REMARKS

The Applicant gratefully acknowledges that the present application has been found in condition for allowance. In response to the Examiner's comments regarding required amendments, the Applicant has made the changes to the drawings and to the disclosure, as set out hereinabove. The Applicant also provides the following comments.

Amended

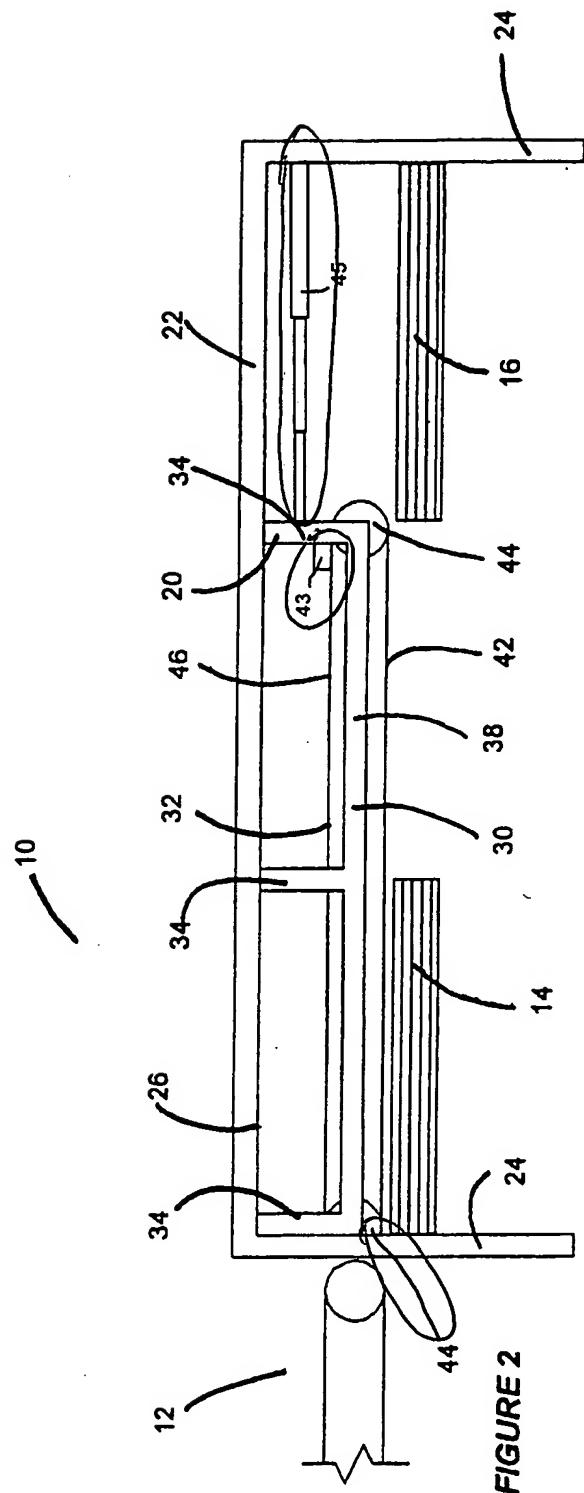
Also, in response to the Examiner's objection under 37 CFR 1.83(a), the Applicant has amended Figures 2, 3, 14 and 15 to show various features of the invention which have been disclosed in the disclosure, and which have also been claimed in the claims. These features include the linear actuator, the conveyor controller assembly, and the conveyor stop and/or clamp. Also, the Applicant has added new Figure 16, which is basically a modified version of Figure 2, in which the conveyor belt has been replaced by a series of rollers, as was described in the disclosure and the claims.

Paragraph 38 has been amended to provide a description of a pneumatically operated piston 45, which acts as a linear actuator, and which has been added to Figure 2.

FIGURE 14

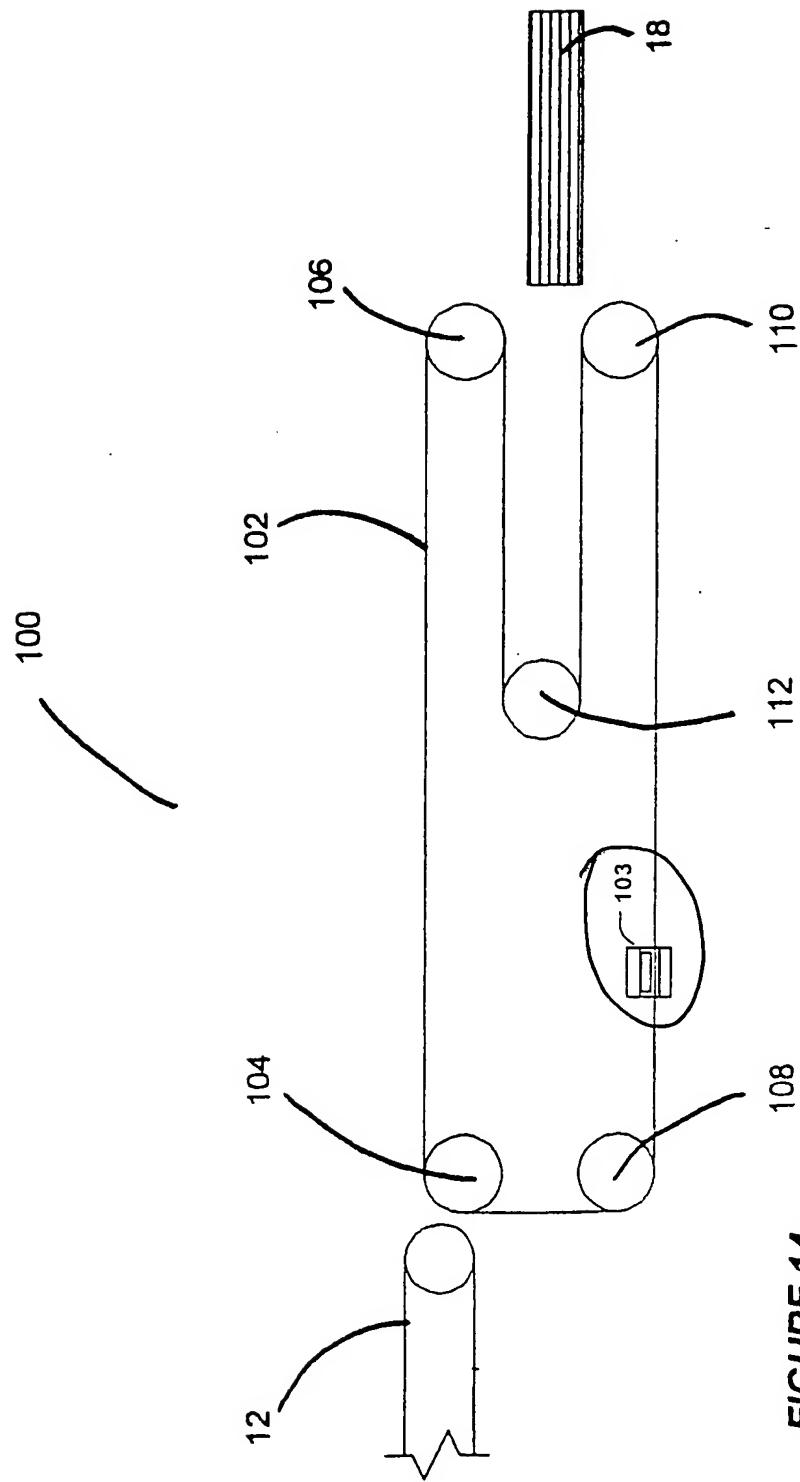
Further, page 11 has been amended, as have Figures 14 and 15, in order to show clamp 103, which clamp can act as a conveyor stop member.

FIGURE 16

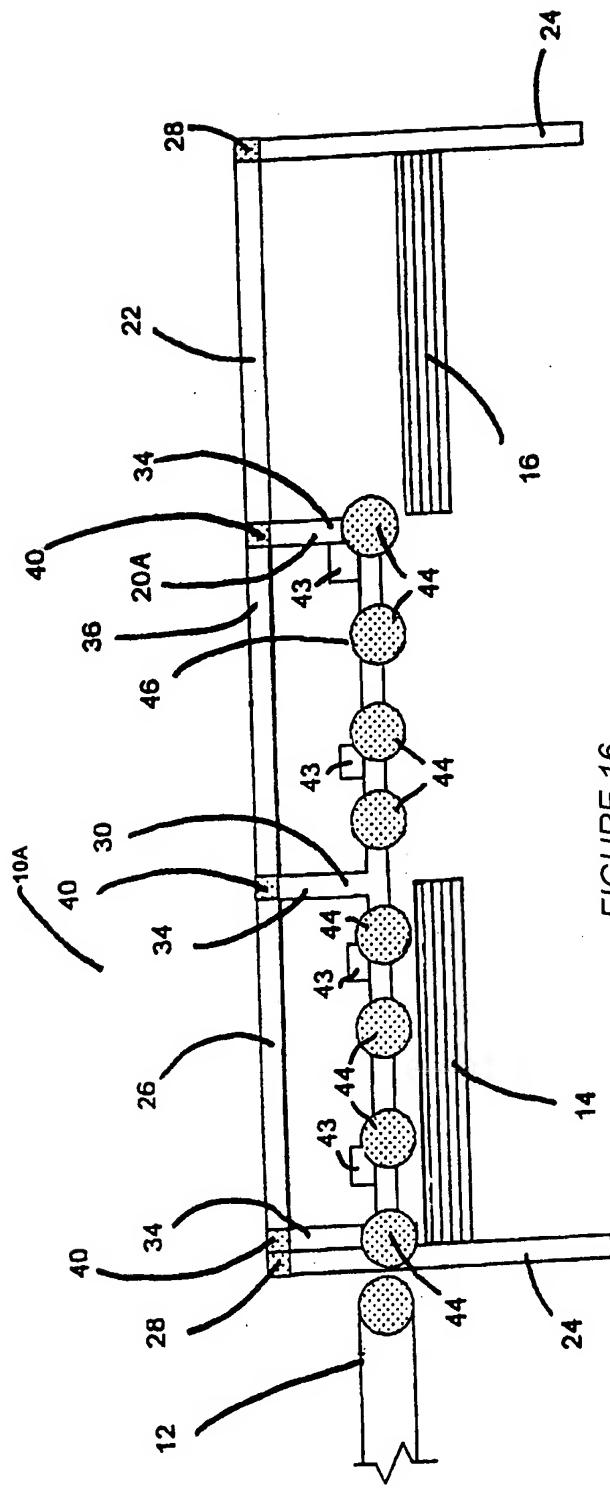
Page 5 has therefore been amended to provide a brief description of Figure 16. Also, page 9 has been amended (namely paragraphs 37 to 39 of record), in order to provide reference numbers to features which were previously described, but which are now shown in the drawings, and to provide a brief description of the invention embodiment now shown in Figure 16. In particular, paragraph 37 has been amended to provide a reference number for motor 43 which has been added to Figures 2 and 3. The motor 43 acts as a first and second conveyance actuator. Also, reference to incorrect reference numerals "42" for the rollers, have been replaced with a correct reference to numerals "44".

Paragraph 39 has been amended, and Figure 16 has been added, to show and further describe an embodiment wherein the conveyor belt of Figure 2 has been replaced by a series of rollers.
